## STAFF REPORT

SUBJECT: H-2021-0062  
Meridian South Fire Station & Police  
Substation Conditional Use Permit

LOCATION: 2385 E. Lake Hazel Rd  
South side of E. Lake Hazel Rd, between  
S. Locust Grove Rd. and S. Eagle Rd.

### A. Site Plan (date: 8/26/2021)

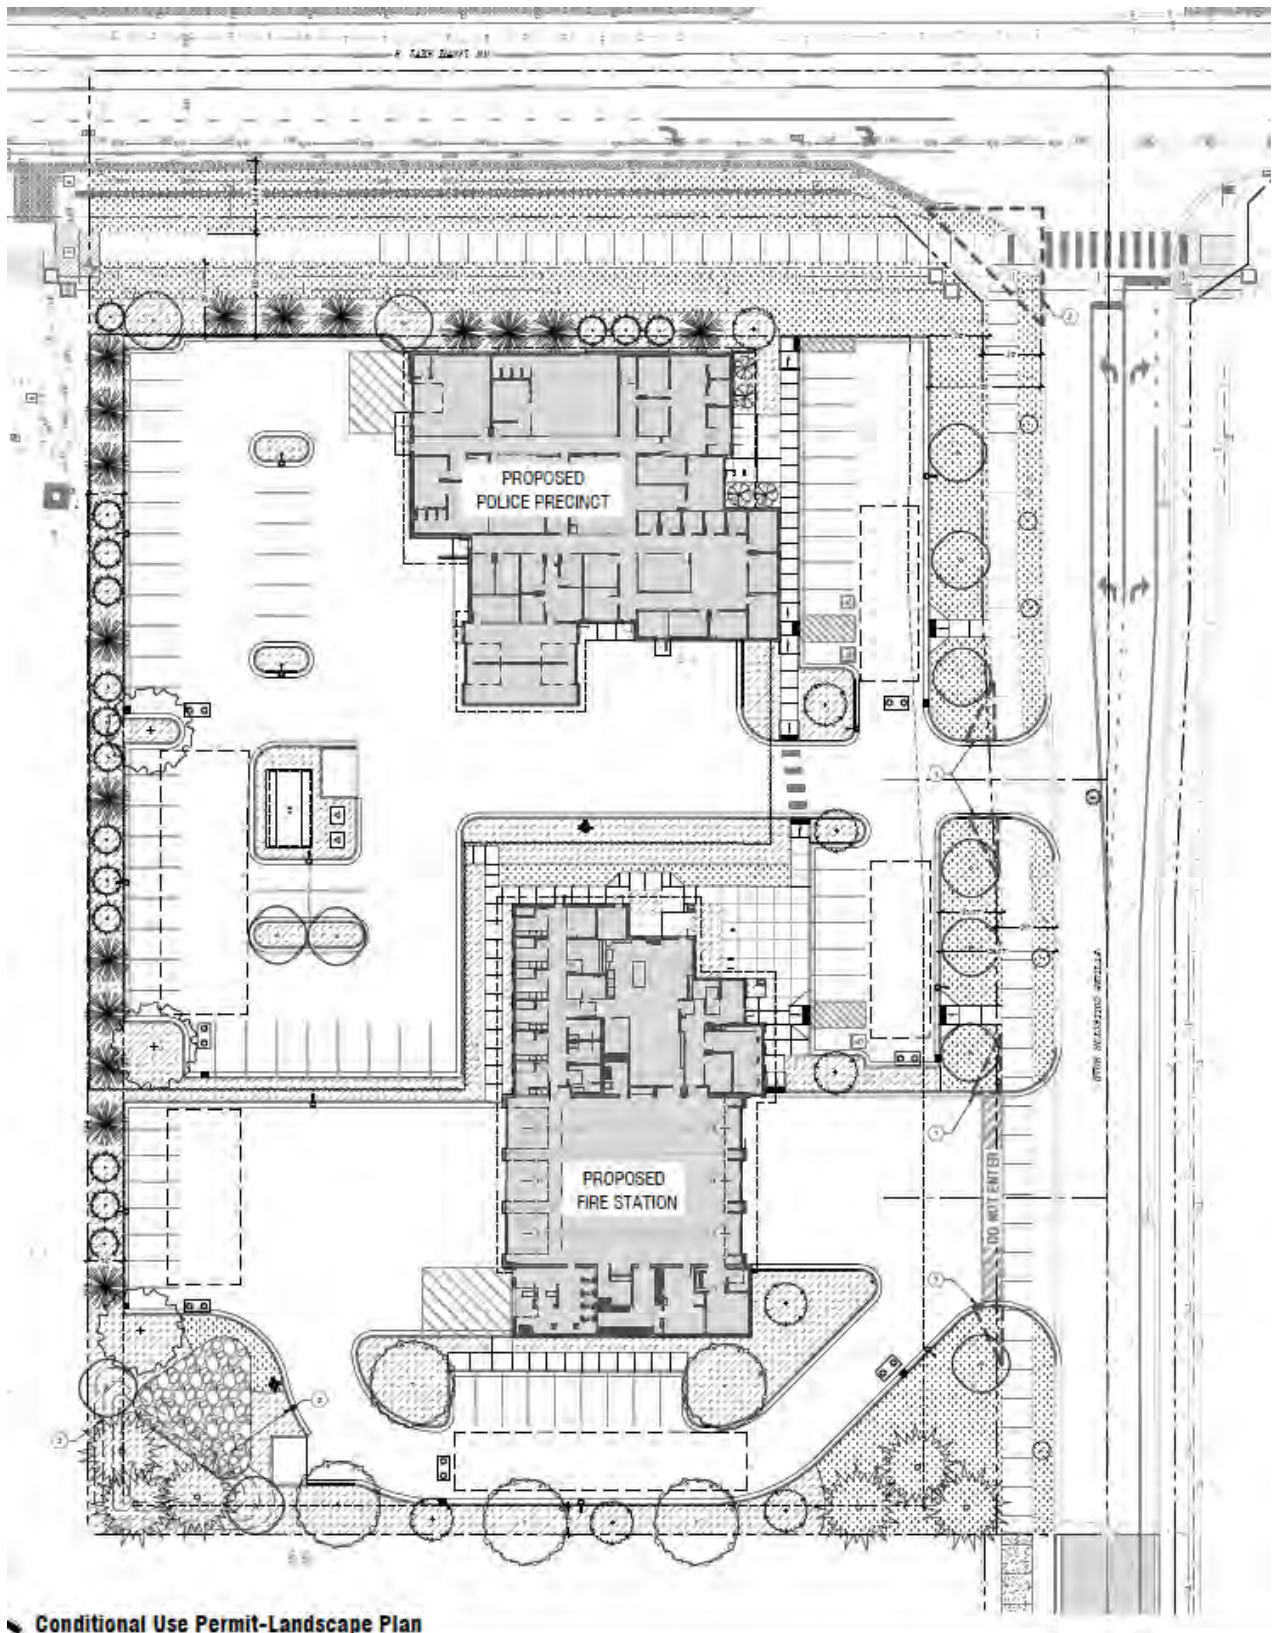
UDC 11-3C-5 requires one (1) space for every five hundred (500) square feet of gross floor area. With 22,710 sq. ft. between the first station and the police sub-station, 46 parking spaces are required. The concept plan indicates 53 parking spaces for the police substation, and 25 parking spaces for the fire station. 12 of the parking spaces would be covered and would be for the use of the police vehicles only. The concept plan shows at least 3 additional spaces for fire apparatus at the east side of the fire station.

The parking plan appear to meet most of the landscaping requirements of UDC 11-3B-8 except there are several landscape islands which do not reflect trees as required by UDC 11-3B-8. Also, pedestrian crossings across the drive aisles are striped whereas UDC 11-3A-19 requires the internal pedestrian walkway to be distinguished from the vehicular driving surfaces through the use of pavers, colored or scored concrete, or bricks. This should be addressed at the time of CZC submittal.

Wrought-iron security fencing of up to 8' in height is shown on the site plan. Staff notes fencing height is limited to 6' in height in the R-8 zone district. The City should apply for alternative compliance concurrently with the CZC.

1. A Certificate of Zoning Compliance and administrative design review application is required to be submitted to the Planning Division and approved prior to submittal of building permit applications. The buildings shall either meet all architectural requirements of the Architectural Standards Manual (ASM) or there should be a request for a design exception as part of the CZC submittal.

11. All ACHD conditions of approval shall be complied with.
12. All parking lots shall meet the standards as required per UDC 11-3B-8C.
13. All proposed fencing and/or any fencing shall be constructed as required by the UDC, consistent with the standards as set forth in UDC 11-3A-7 and 11-3A-6B, as applicable, or developer shall submit a concurrent alternative compliance to increase the fence height.

# D. Police Station Elevations (date 8/26/2021)

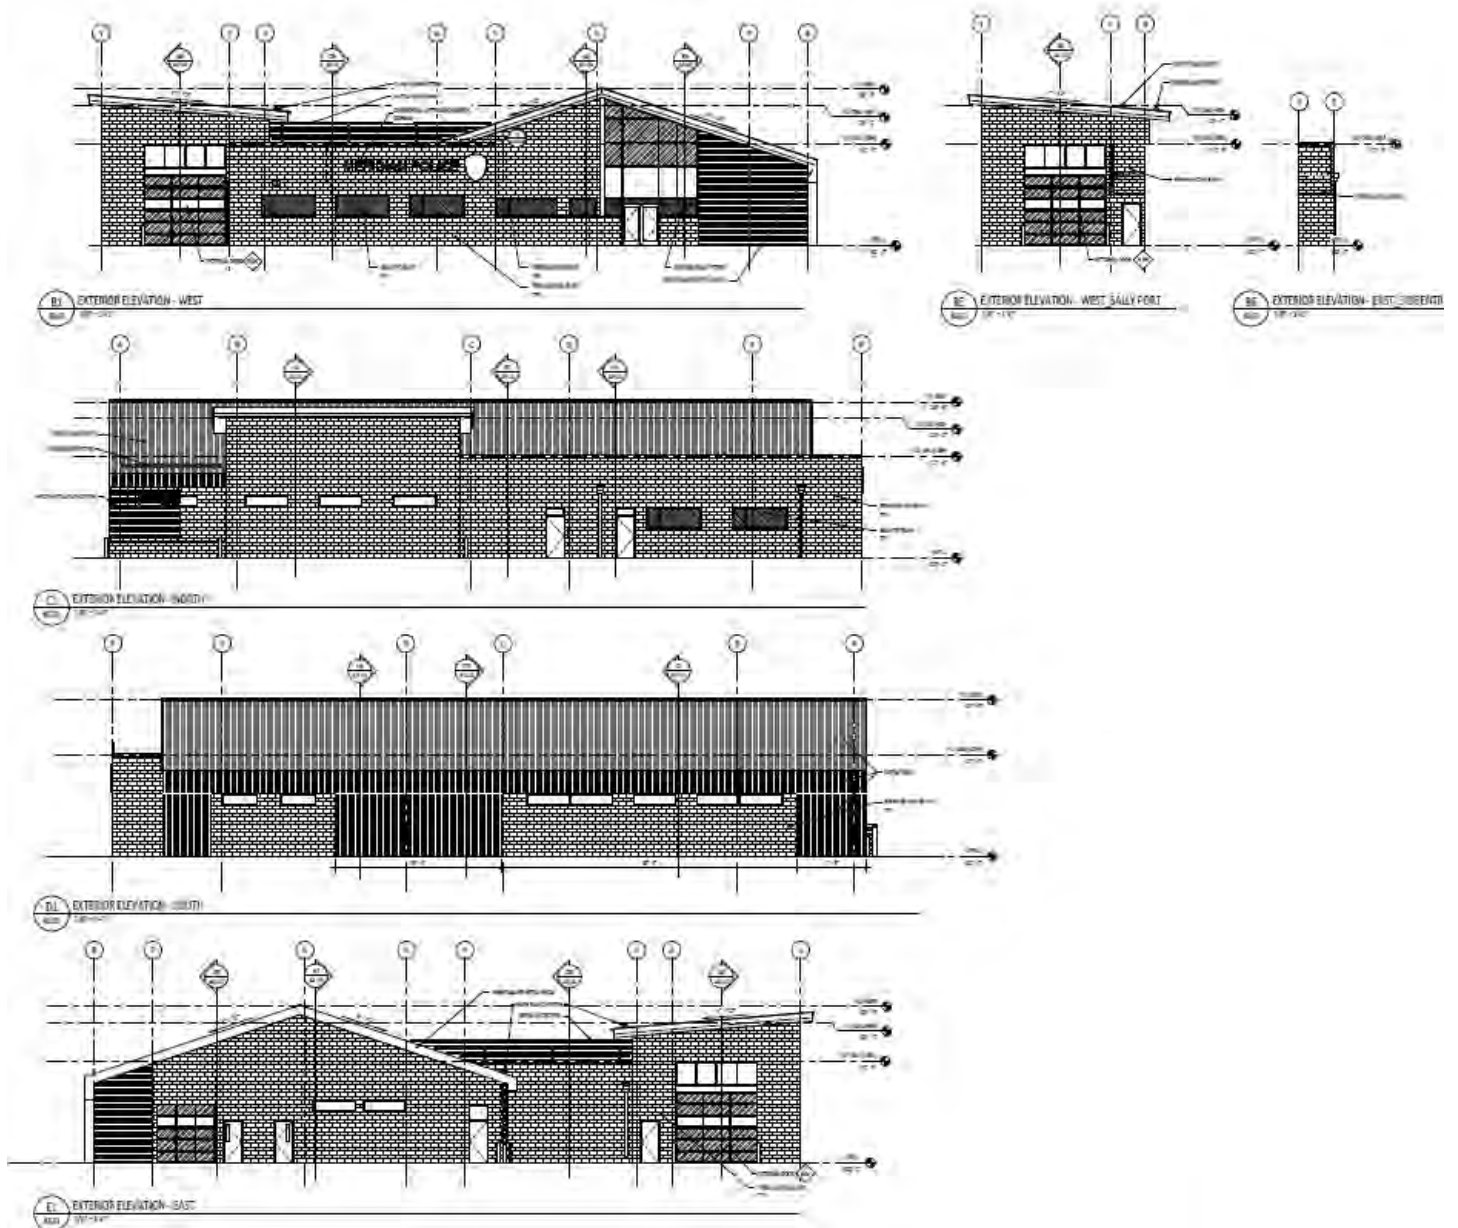
The City has submitted colored elevations for both buildings. Architecture consists of sloped roof buildings with CMU and wood grain metal panel as the primary field materials.

Staff is not certain the building elevations as submitted meet the minimum requirements of the ASM for commercial buildings. The only field materials indicated on the elevations are smooth face CMU and horizontal metal panel whereas 5.1B requires at least two distinct field materials (material of more than 20% of the façade) and only allows metal panel and untextured concrete as a field material if there are at least two other qualifying field materials. At least 30% of the façade must use a combination of concrete, masonry, stone or unique variation in color around the base of the building, whereas it does not appear there are any distinct materials along the base. It does not appear there is at least 30% fenestration or a fenestration alternative as required per ASM 3.3E on the facades of the buildings. Finally, the elevations that were approved as part of the annexation indicated timber frame accents and overhangs over entrances, whereas it appears these elements have been removed from the updated drawings. At the time of Certificate of Zoning Compliance (CZC) and Design Review (DE) the standards of the ASM must be met, or design exceptions may be granted.

5. All structures shall comply with the design standards listed in the Architectural Standards Manual and the design standards listed in UDC 11-3A-19. An application for Design Review shall be submitted concurrently with the Certificate of Zoning Compliance application and approved prior to submittal of building permit applications.
